ADA Curb Ramp New Construction Inspection Form (Parallel)

NW Curtis St

23885.56

NW Pacific

PARALLEL RAMP (PL)

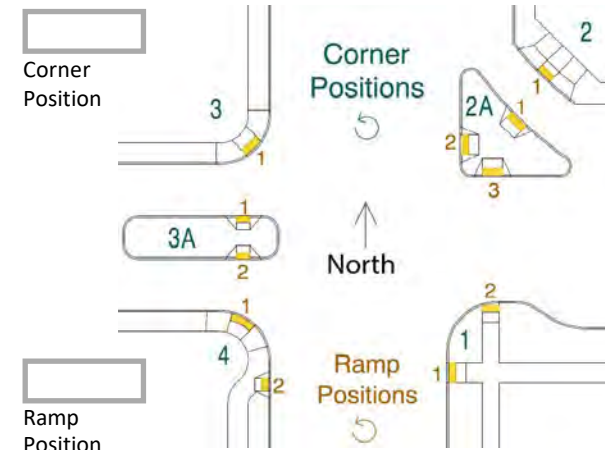
8.5 \leq |5.0%| ☒ $>$ |5.0%| ☐

2.6 \leq 2.0% ☐ $>$ 2.0% ☒

8.5 \leq 8.3% ☐ $>$ 8.3% ☒

midblock west side, IITD
